CITY OF BOULDER
PLANNING BOARD MEETING AGENDA
DATE: August 4, 2016
TIME: 6 p.m.
PLACE: 1777 Broadway, Council Chambers

5. **PUBLIC HEARING ITEMS**
   A. AGENDA TITLE: Public hearing to consider Site Review application, LUR2015-00012, to develop the Armory site (The Armory Community), an 8.55-acre site located at 4750 Broadway (the southeast corner of Broadway and Lee Hill Dr.), with a mixed-use project with up to 200 dwelling units and 8,400 square feet of storefront retail along Broadway and two new street connections (13th Street and Zamia Avenue). The proposal includes a 23 percent parking reduction request to permit 261 parking spaces where 341 are required, but otherwise contains no other modifications to the Land Use Code.

Applicant: Bruce D. Dierking
   Property Owner: The State of Colorado

SHEET NUMBER:
A-3.03

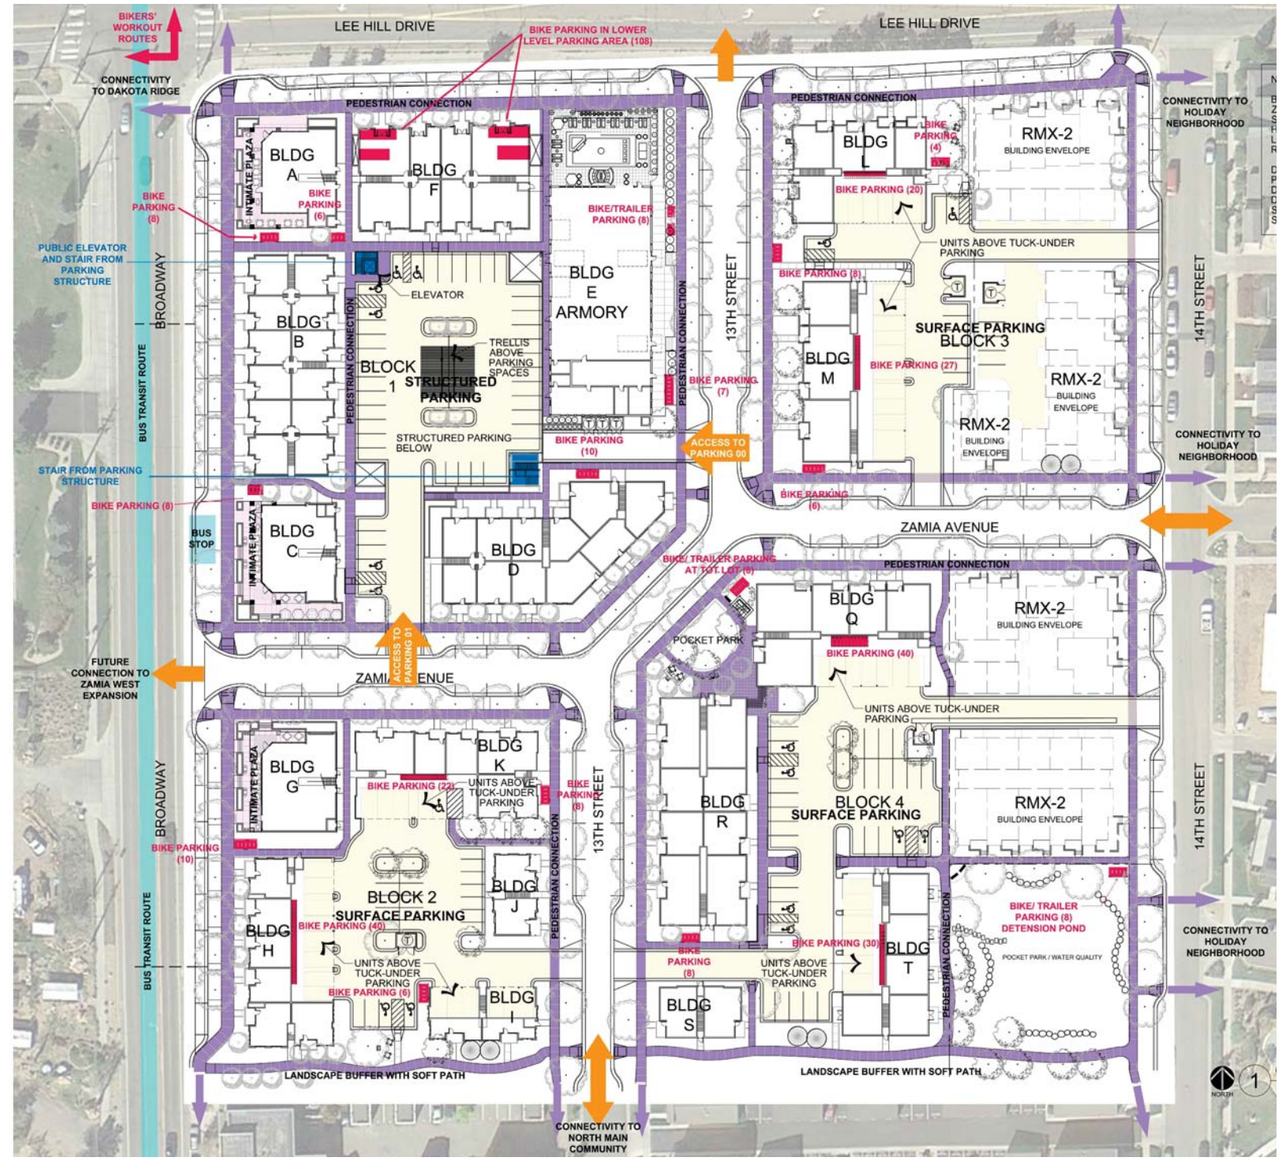
1. On Sheet A-1.02, please revise the plan sheet to remove the engineering variances because engineering variances are not part of the site review approval process.
2. On Sheet A-3.03, the site plan needs to be revised for Block 2 to show six additional short-term bicycle parking spaces consistent with the data provided on Sheet A-3.03.

The bicycle parking spaces are distributed throughout the site to service residents and visitors. See Site Review Submittal Sheet A-3.03 for additional information.

SHEET NUMBER:
A-3.04

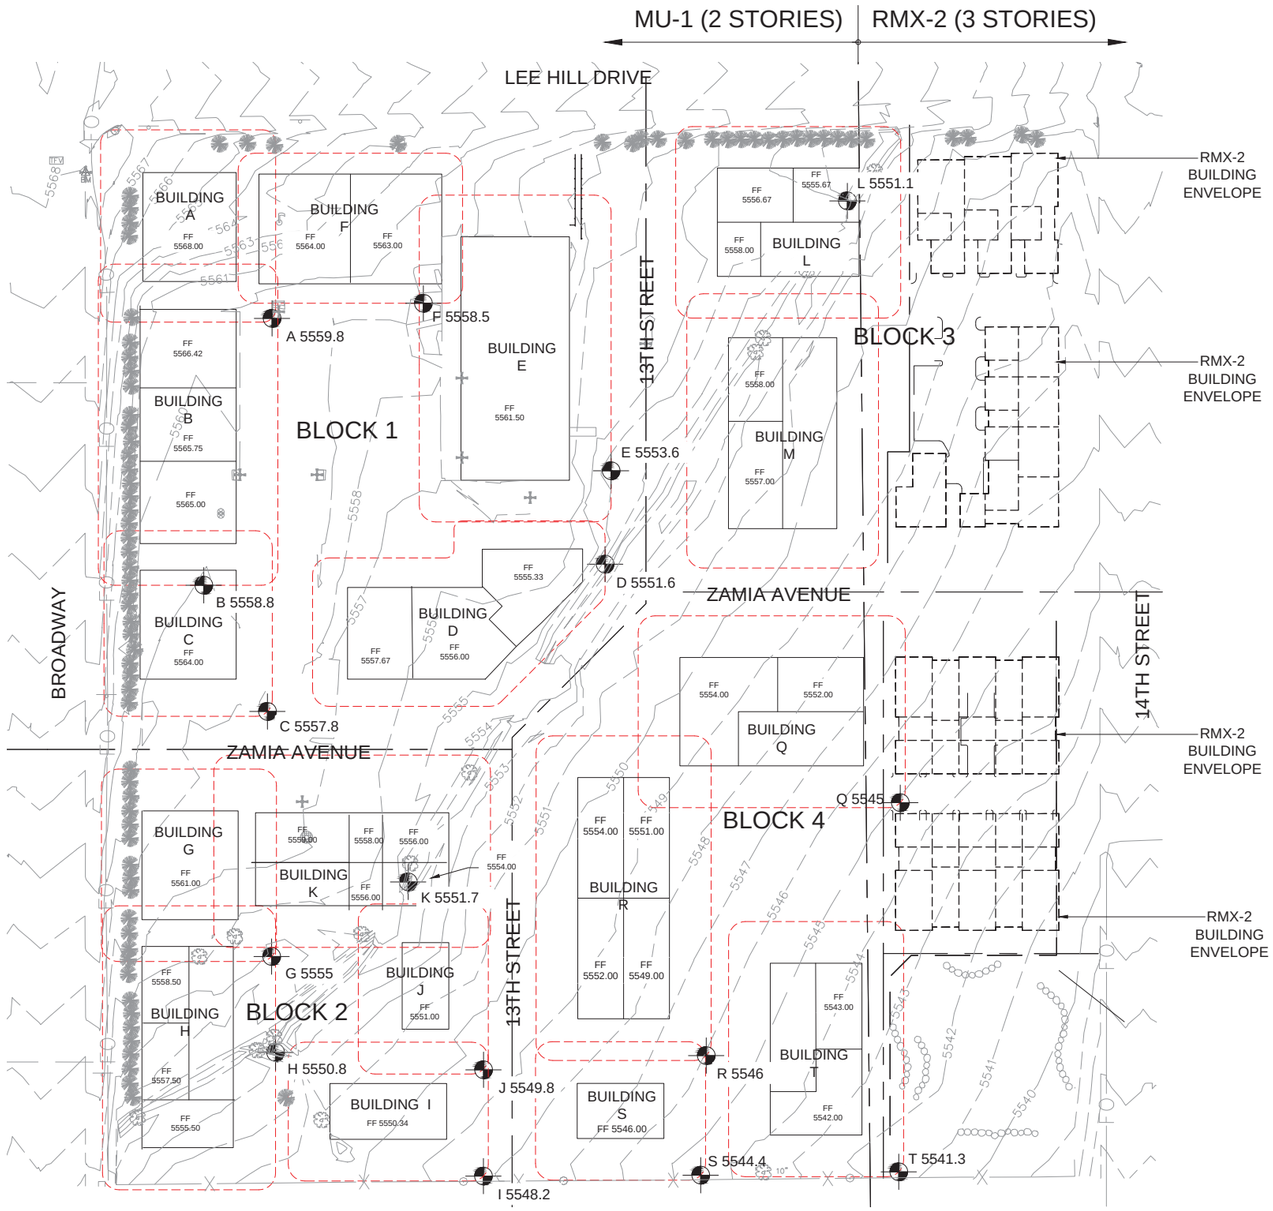
1. Please add the data source for the building height analysis plan on Sheet A-3.04

12. Please remove the RMX-2 building low point information from Sheet A-3.04.
13. If the intent is to allow for any number of bedrooms per unit in the RMX-2 zone, then the parking information and parking reduction request included in the application materials should reflect the maximum possible parking requirement. Please revise the RMX-2 data table on Sheet A-4.16 to reflect the maximum number of bedrooms and adjust the parking information accordingly.

A-4.05

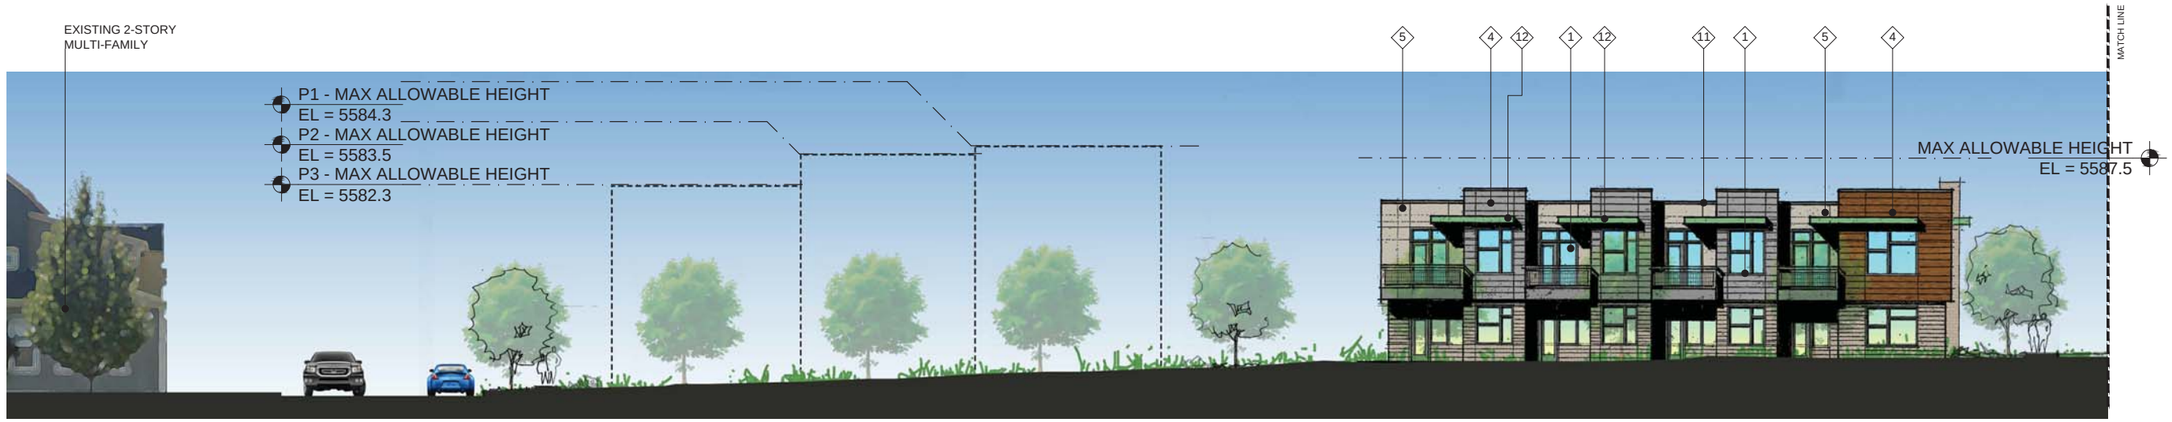
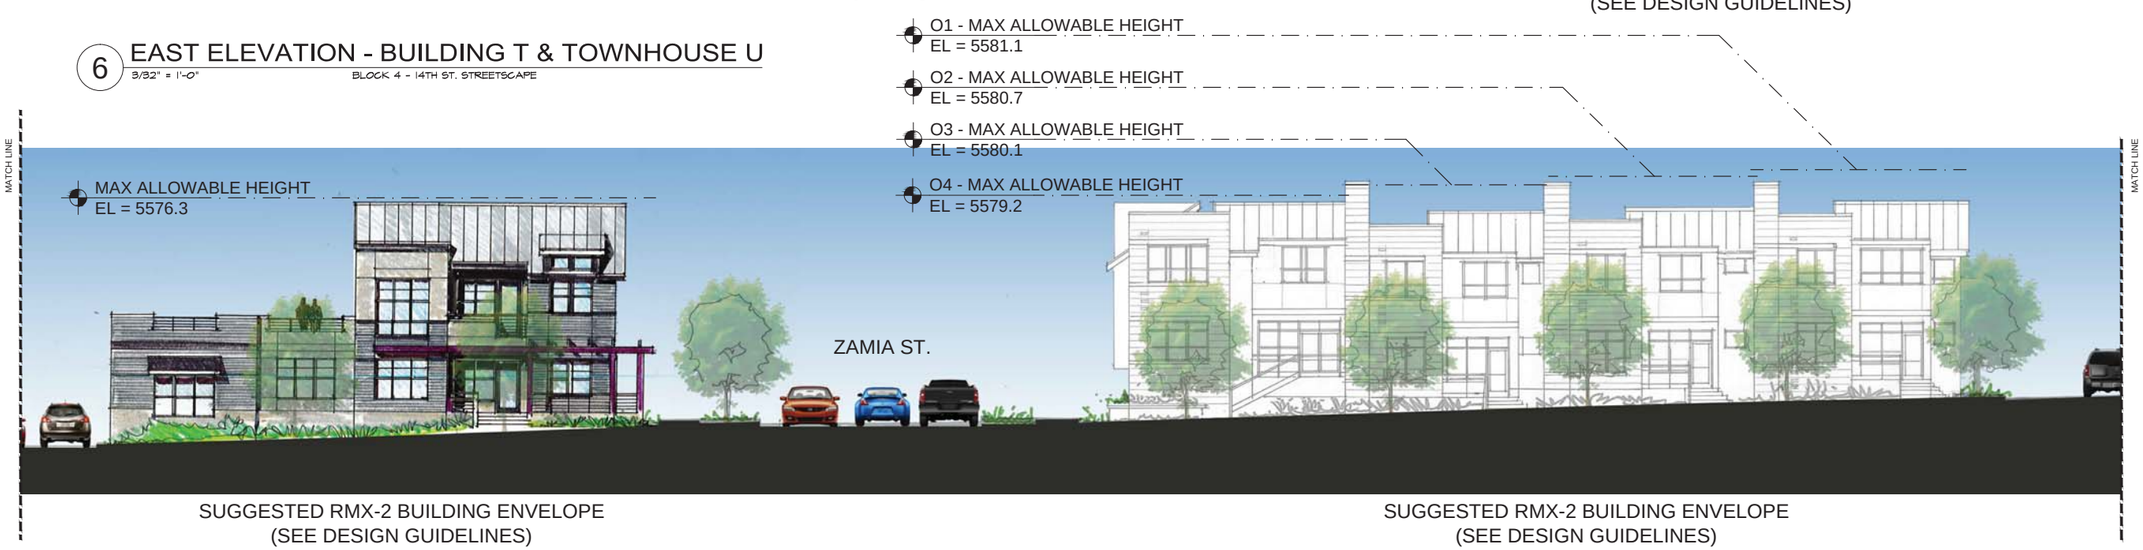
9. Per the elevations shown on Sheet A-4.04 and A-4.05, Townhouses U and P appear to be exceeding the maximum allowable height. Please clarify whether or not a height modification is in fact being requested.

10. Sheet A-4.05 incorrectly shows Zamia St. to the north of Townhouse U. Please revise.

6. Please address the discrepancy between the site plan/first floor plan A-4.01 Building T and the elevation on A-4.05. Entries are not illustrated as proposed in the plan.

SHEET NUMBER:
A-5.01

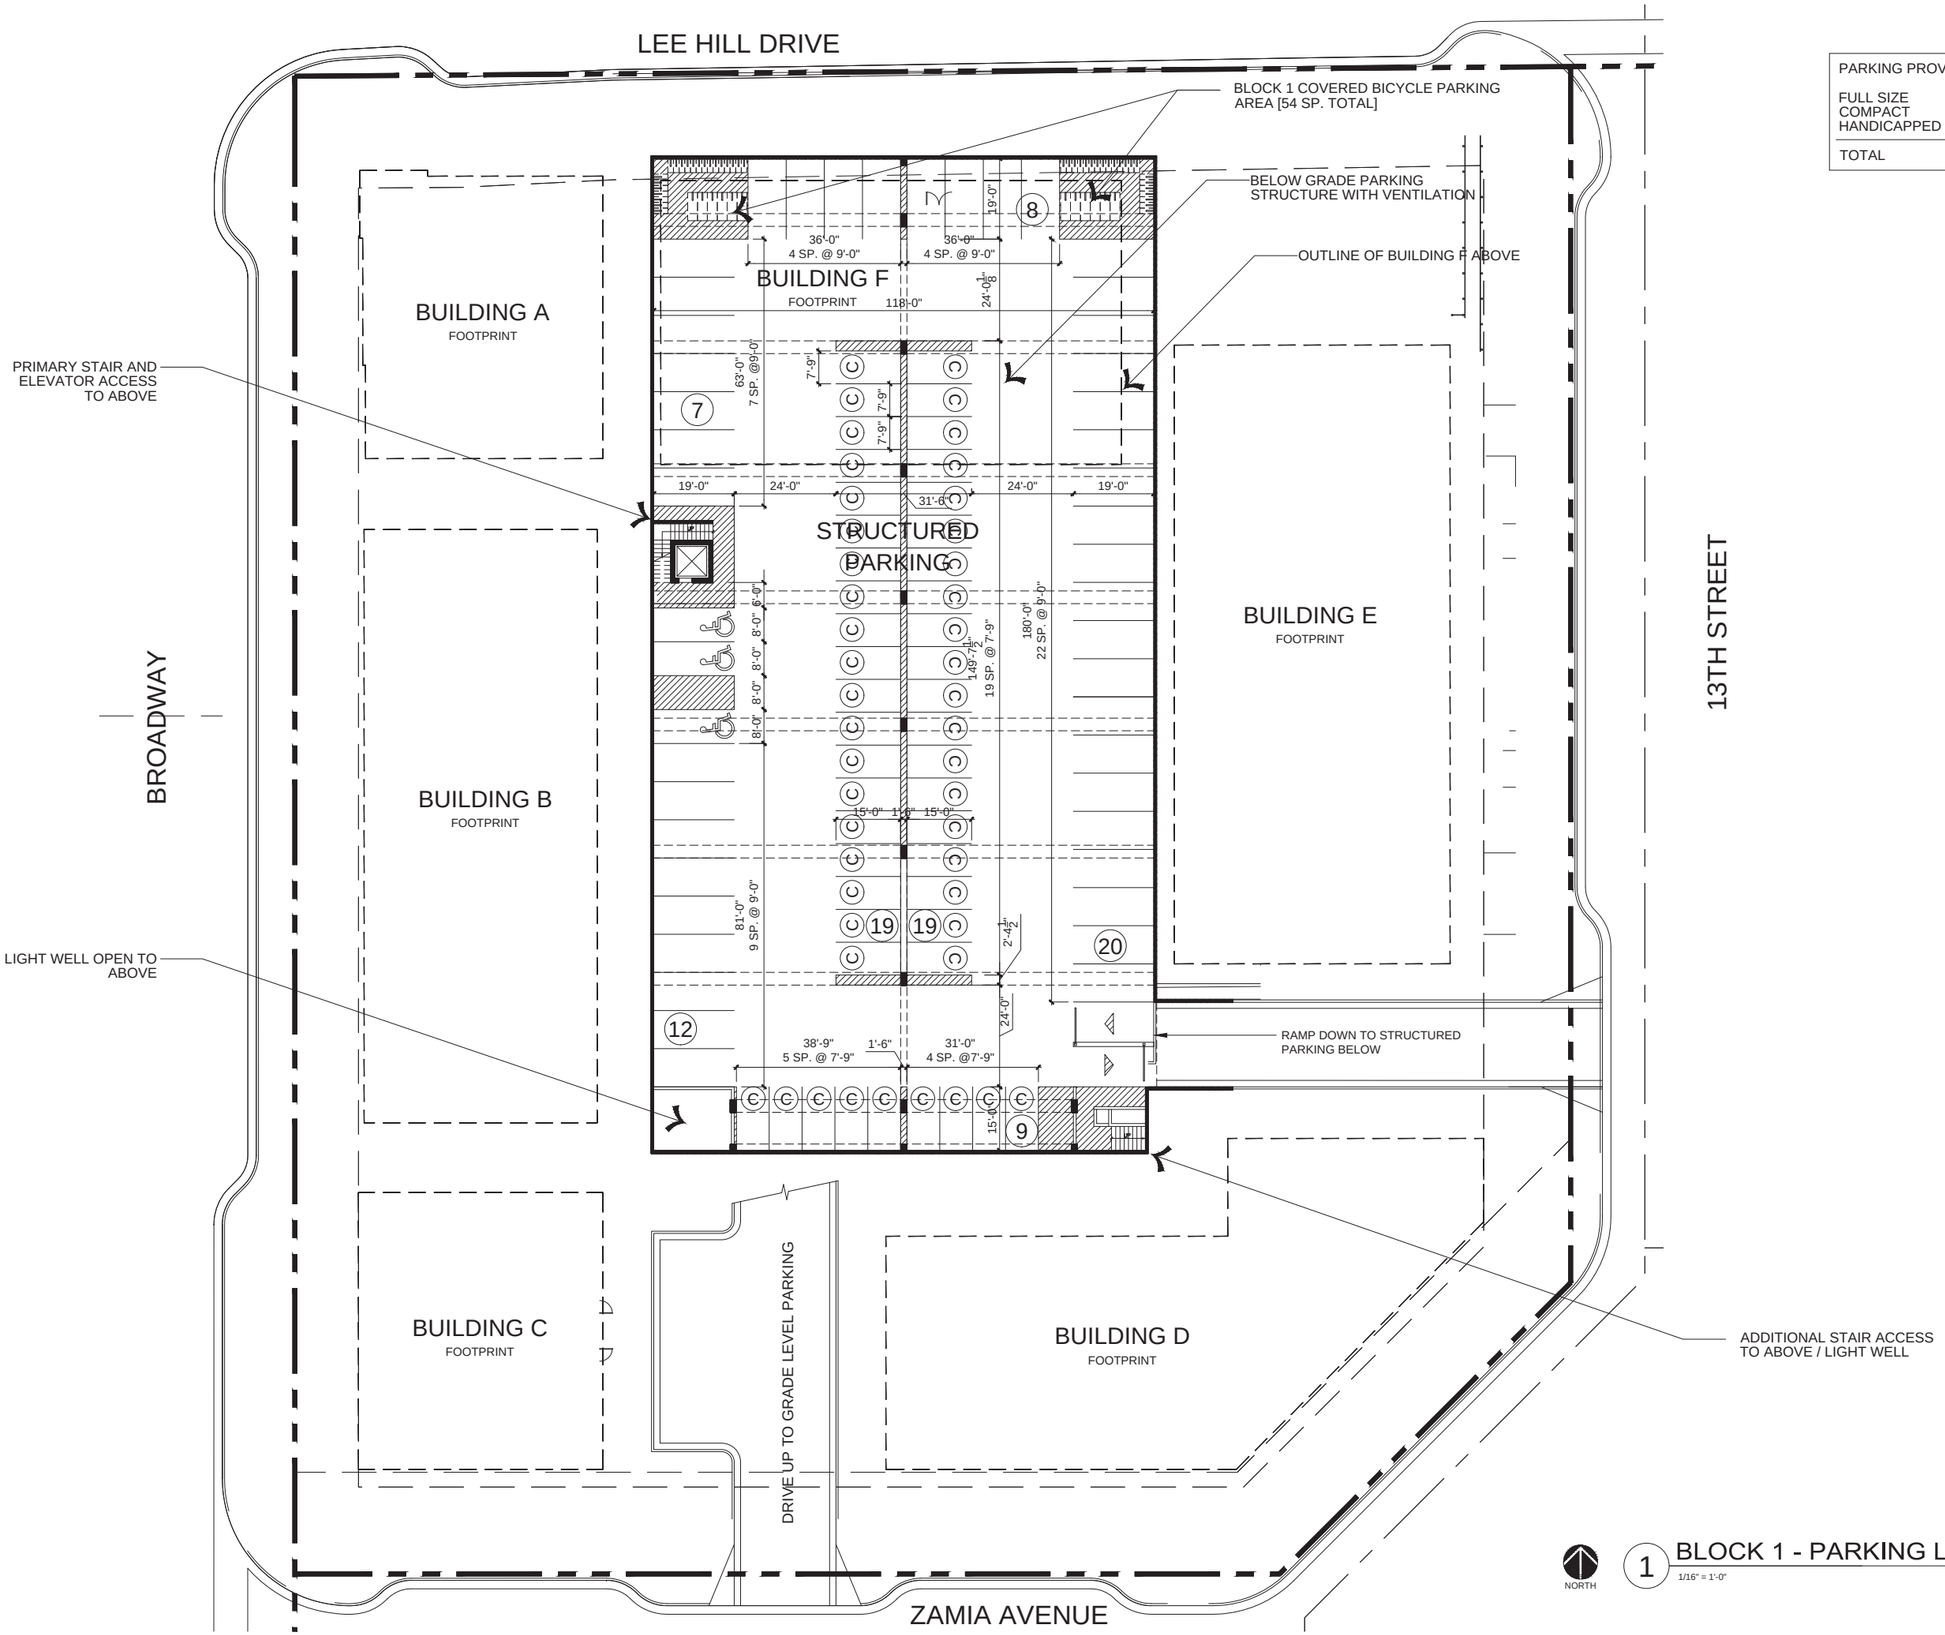
4. On Sheet A-5.01, the underground (structured) parking needs to show the structural columns because the columns will impact the parking layout and number of parking spaces as currently shown on the site plan sheet.
